Sheringham Shoal and Dudgeon Offshore Wind Farm Extension Projects

Appendix 1: In-Principle Cromer Shoal Chalk Beds (CSCB) Marine Conservation Zone (MCZ) Measures of Equivalent Environmental Benefit (MEEB) Plan (Revision C) (Tracked Version)

March 2023

Document Reference: 5.7.1.1

Figure 8.1 The proposed initial 1km² (light blue polygon) native oyster restoration site search area and the indicative size of the 10,000m² restored reef (red square within blue polygon) in the north-western section of the CSCB MCZ

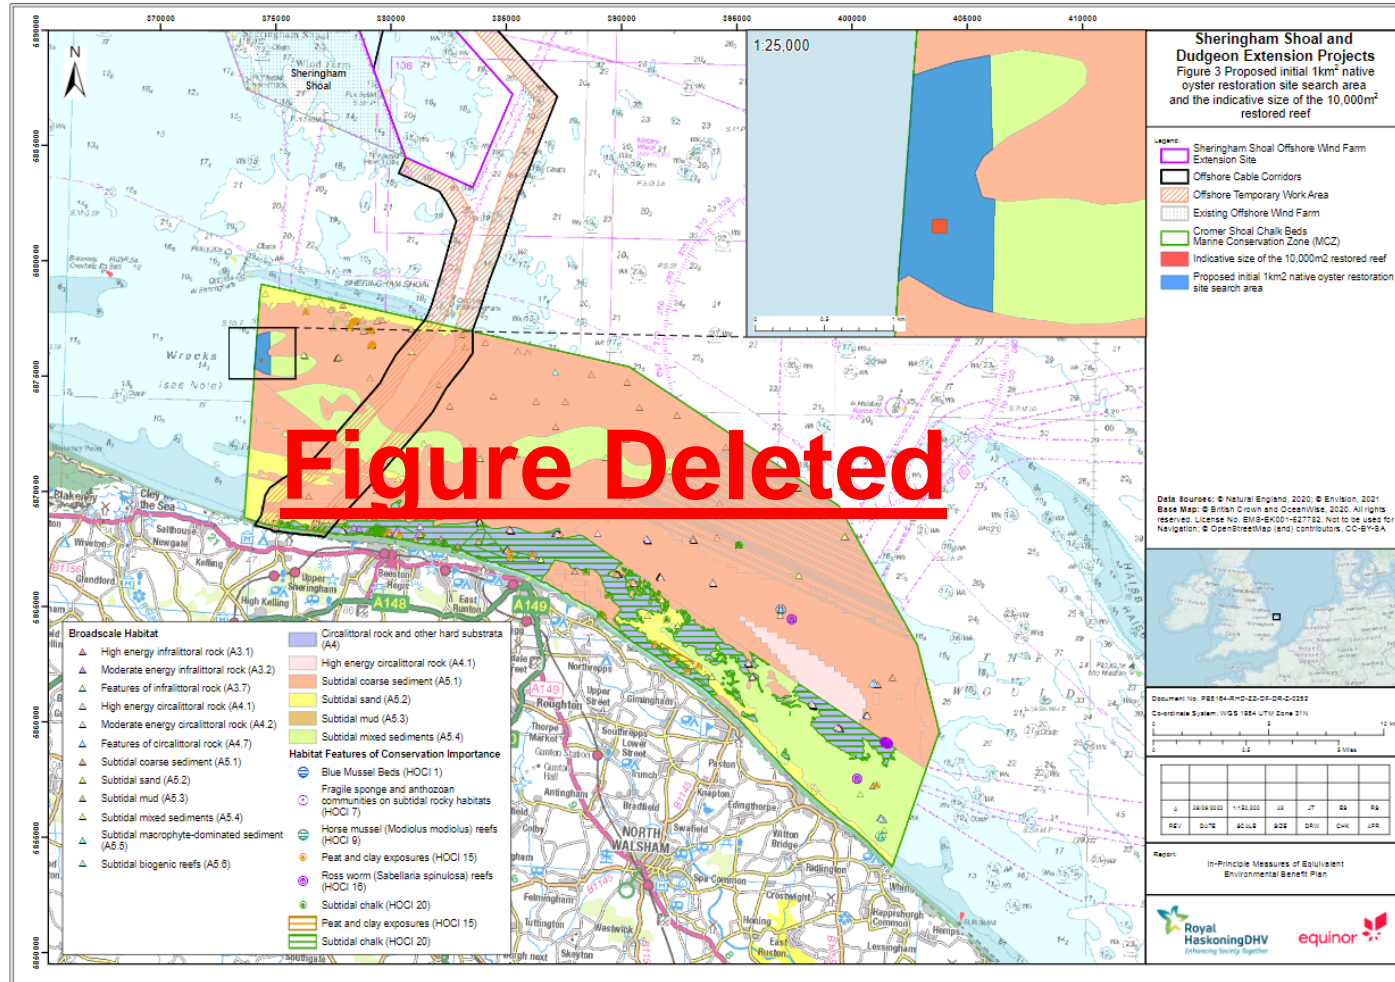
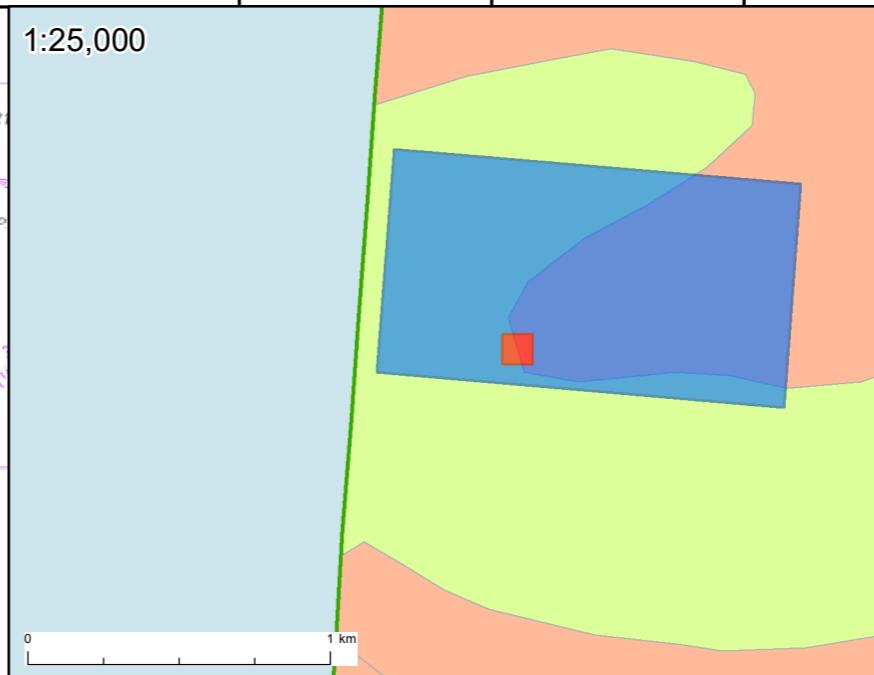
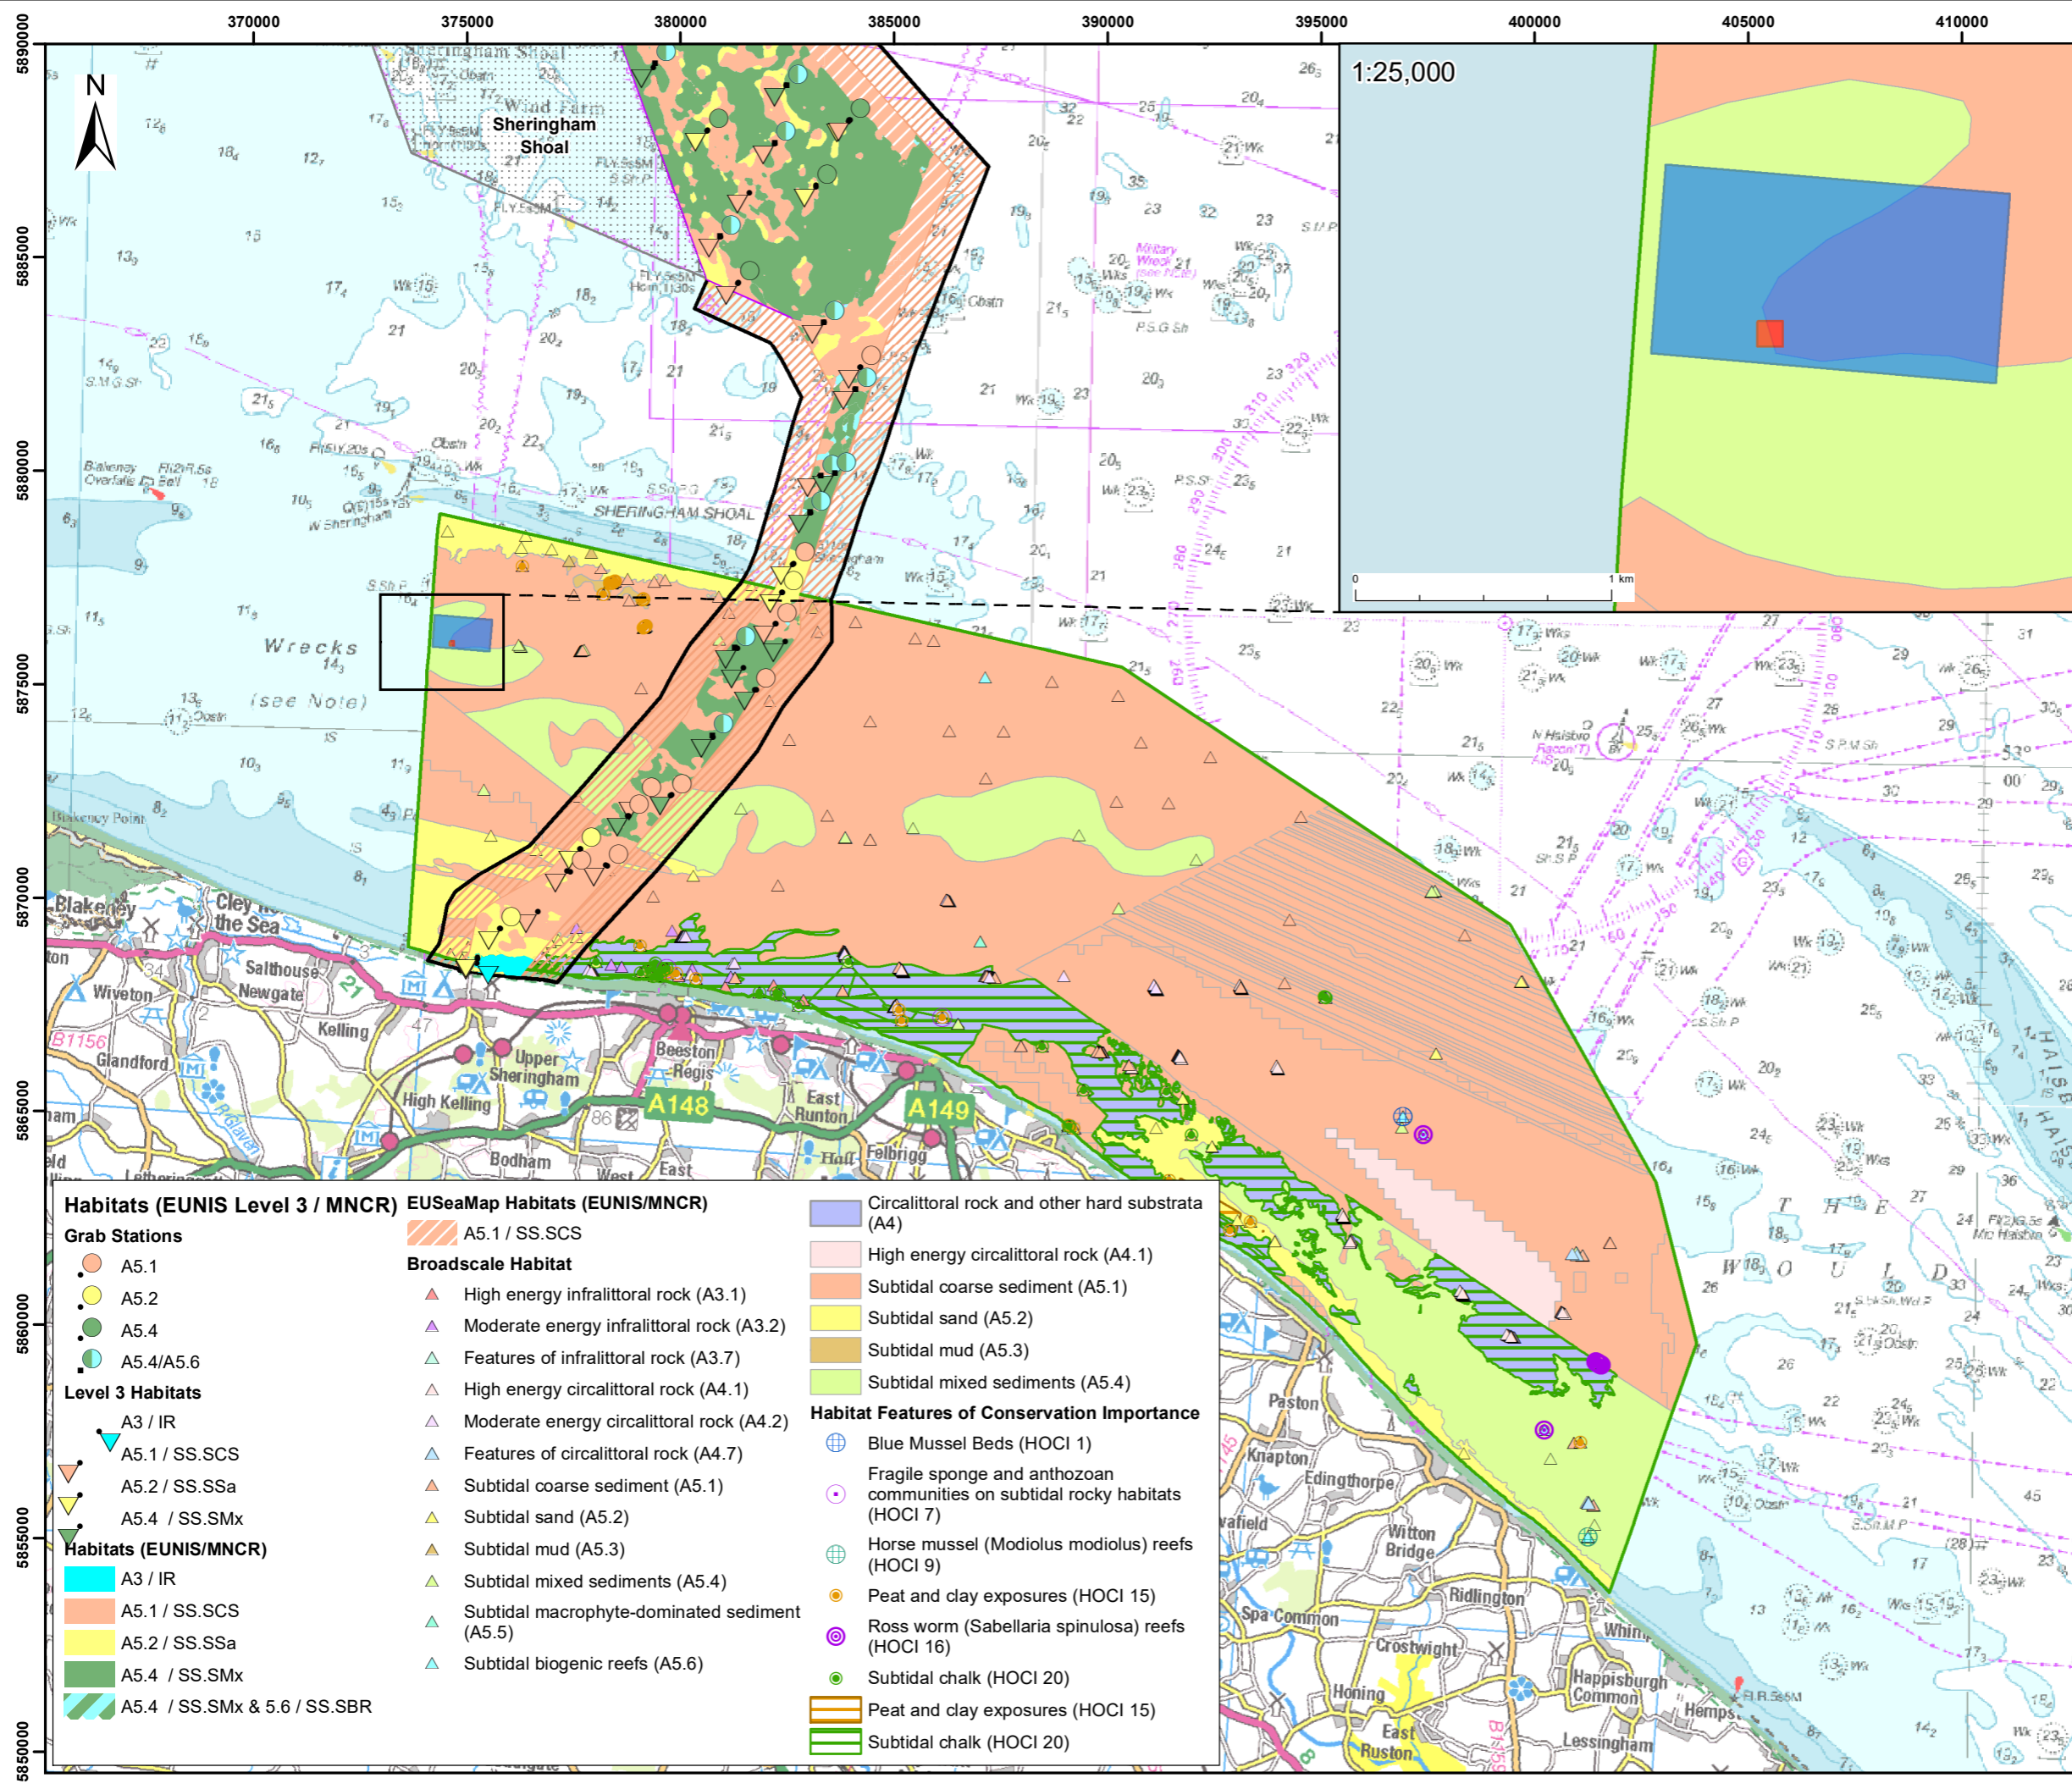
1. This document has been updated at Deadline 2. As noted in **Section 1.2** below, the Applicant updated **Figure 8.1** to address comments from Natural England however an error during PDF'ing meant the updated figure was not incorporated into Revision B and therefore this has now been included in this Revision C.

- **Figure 8.1** updated to address comment from Natural England ‘*Natural England therefore advises against the placement of cultch and restoration of an Oyster bed in the middle of a mixed sediment area. For this to be considered as additionality we advise that it would be better to extend/enhance the area of the mixed sediment on the boundary with impoverished coarse sediment e.g. in the centre of the ‘c’ shaped mixed sediment area or north/south of the blue rectangle*’;

- ~~70.71.~~ The 10,000m² reef would provide a greater than 1:5 ratio of MEEB, offering long term enhanced ecological function to the habitat being lost and restoring a historic feature of the region.
- ~~71.72.~~ **Annex C** identifies a 1km² initial oyster restoration site search area (see **Figure 8.1**). Available data suggests this location provides suitable environmental conditions (see **Section 5.5.2** of **Annex C**) for the successful restoration of native oyster. A targeted survey of this area would be undertaken post consent to confirm the suitability of this location and to select the 10,000m² area for oyster deployment within this search area.
